APPEAL SUMMARY

Appeal ID: 24865	Project Address: 2317 NE Clackamas St
Hearing Date: 5/12/21	Appellant Name: Mildred White
Case No.: B-005	Appellant Phone: 503-253-4283
Appeal Type: Building	Plans Examiner/Inspector: Amanda Rhoads
Project Type: residential	Stories: 2 Occupancy: single family Construction Type: V-B
Building/Business Name:	Fire Sprinklers: No
Appeal Involves: Alteration of an existing structure, occ Change from garage to ADU	LUR or Permit Application No.: 21-008199-LU
Plan Submitted Option: pdf [File 1] [File 2] [File 3] [File 4]	Proposed use: ADU

Appeal item 1

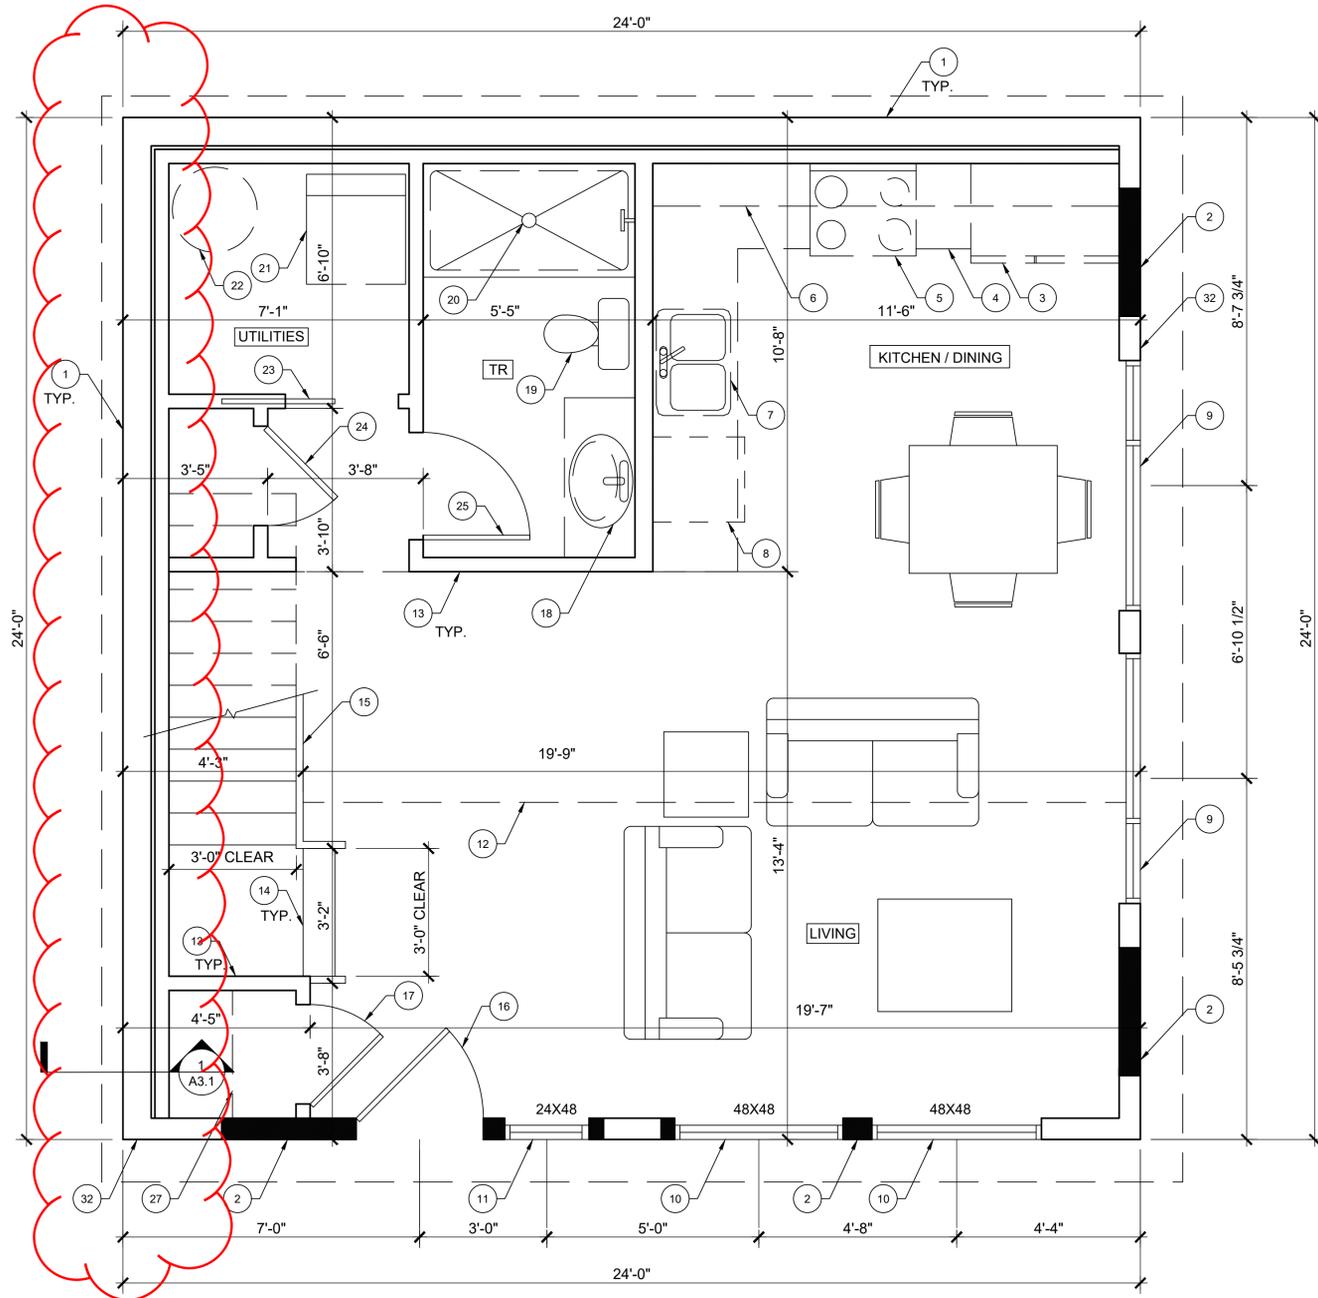
Code Section	Table R302.1
Requires	Projections of exterior walls that are less than 2' to a property line are not allowed.
Code Modification or Alternate Requested	Existing eave projection located within 2' of property line to remain and install alternate assembly which provides eave protection.
Proposed Design	<p>The existing west wall is a one-hour rated cmu wall, but the wood eave projects 4" from the wall, so that it ends within 2" of the property line. The proposed design is to install two layers of 5/8" type 'X' gypsum board on the underside of the existing eave, double 2x blocking is to be provided between the top plates of the cmu wall and the roof sheathing, two layers of 5/8" type 'x' gypsum board are to be installed on the interior side of the top plates and 2x blocking, and one layer type 'X' gypsum board is to be installed tight against the roof sheathing within 4' of the property line. Notes on the wall section provide additional limitations regarding proximity to property line and openings within the wall and roof within 3' of property line.</p> <p>This condition occurs at the west side only. The north side is located within 3' of the property line but there is no eave and the wall is a one-hour rated cmu wall.</p>

Reason for alternative	<p>The existing garage is located 6" from the west property line. The existing wall is one-hour rated from both sides but has a wood eave extension. The two layers of 5/8" thick, fire rated gypsum board will limit the spread of fire to the adjacent property.</p> <p>The requirement for fire rating is due to proximity to the property line and potential for an adjacent building to spread fire. The small eave provides minimal potential for the spread of fire and when wrapped with gypsum board this potential is mitigated.</p>

This alternate is proposed in order to retain the existing eave and eliminate extensive exterior work which would require access from, and disruption to, the neighboring property.

Alternate one hour assembly for West eave of existing garage within 2 feet of property line: Hold for additional information. See note below regarding the process for submitting additional information. Appellant may contact John Butler (503 865-6427) or e-mail at John.Butler@portlandoregon.gov with questions.
